# Access Compliance Report

## Public Rights-of-Way

Intersection ID: 42988	Main Street: UNIVERSITY_CITY_BV	Cross Street: UNIVERSITY_WALK_CR	Location: S
ADA ID: 16D82B0F0DA9	Ramp Type: BlendTrans1	Initial Pass/Fail: Fail	Overall Compliance: No
		Severity Score: 10

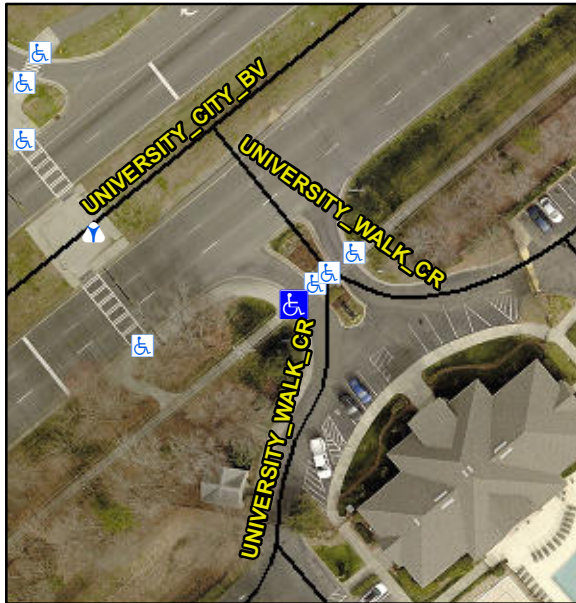
**RP < 5%**

**Not Found, R304.5.1, R304.2.1, R304.2.2-Perp, R304.3.2-Para, R304.5.3, R302.7.2, R304.5.4**

Compliance	Description	Data	Compliance	Description	Data
N/A	Ramp Length (in)	61.0	Yes	BlendTrans Slope (%)	0.2
No	Ramp Width (in)	47.5	Yes	BlendTrans XSlope (%)	3.3
N/A	Flare Type LT	N/A	N/A	Flare Type RT	N/A
N/A	Flare Slope LT (%)	N/A	N/A	Flare Slope RT (%)	N/A
N/A	Flare Traversable LT?	N/A	N/A	Flare Traversable RT?	N/A
No	Landing Length (in)	N/A	N/A	DWS Provided?	N/A
No	Landing Width (in)	N/A	N/A	DWS Contrast?	N/A
No	Landing Slope (%)	N/A	N/A	DWS Length (in)	N/A
No	Landing X Slope (%)	N/A	N/A	DWS Full Width?	N/A
N/A	Landing Curb? (Y/N)	N/A	N/A	DWS Offset (in)	N/A
N/A	Shared Landing?	N/A			
Yes	Gutter Ponding?	N/A	No	Gutter Slope (%)	N/A
No	Gutter Lip Ht (in)	N/A	No	Gutter X Slope (%)	N/A
N/A	Painted X Walk1?	Yes	N/A	Painted X Walk2?	N/A
	X Walk 1 Direction	To NE		X Walk 2 Direction	N/A
	X Walk 1 Width (in)	57.0		X Walk 2 Width (in)	N/A
	X Walk 1 Slope (%)	1.2		X Walk 2 Slope (%)	N/A
	X Walk 1 X Slope (%)	2.7		X Walk 2 X Slope (%)	N/A

Yes	Ramp inside XWalk1?	Yes	N/A	Ramp inside XWalk2?	N/A
	Road Slope (%)	N/A		Clear Space?	N/A
	Road X Slope (%)	N/A	N/A	Clear Space to XWalk (in)	N/A
Yes	Any Obstructions?	N/A	Yes	Storm Grate/Utility Hazard?	N/A
	Obstruction Type			Storm Grate/Utility Type	
		N/A			N/A
			Yes	Surface Condition? (G/P)	Good
			No	Curb Slope (%)	11.5

**Remove & Replace Curb Ramp With Two New Directional Ramps or Equivalent. Remove & Replace Gutter.**
